RENESAS TECHNICAL UPDATE

Product Category	Packages	Document No.	TN-WRP-A008A/E	Rev.	1.00
Title	Notification of changing the shipment tray for PTQP0144LC-A (TQFP144-16x16-0.4).		Information Category	Packing change	
Applicable Product	All devices whose package code is PTQP0144LC-A (TFP-144/144V). Please refer to the products list.	Lot No.	Reference Document	-	
		-

1.2 Comparative outline

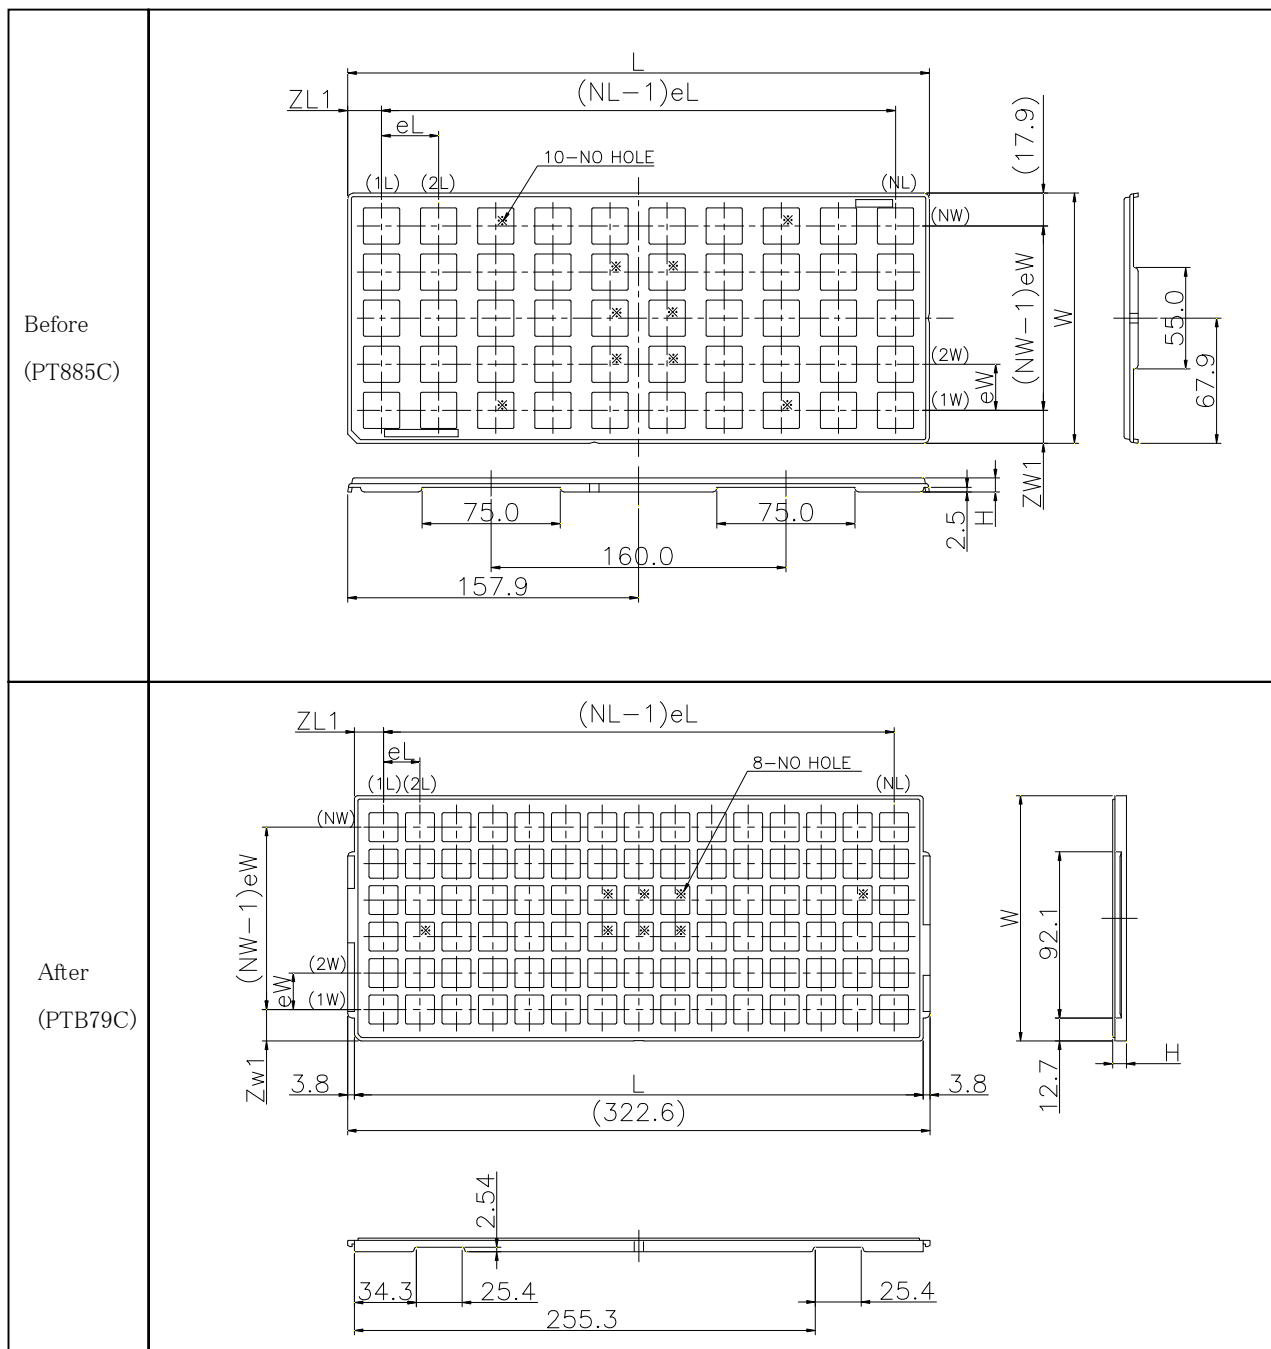
We will change the shipment tray for the package PTQP0144LC-A (TQFP144-16x16-0.4), from the Renesas custom tray (PT885C) to the JEDEC standard tray(PTB79C).

According to this change, the number of devices loaded in a tray, the pocket pitch, and the heat-proof temperature change.
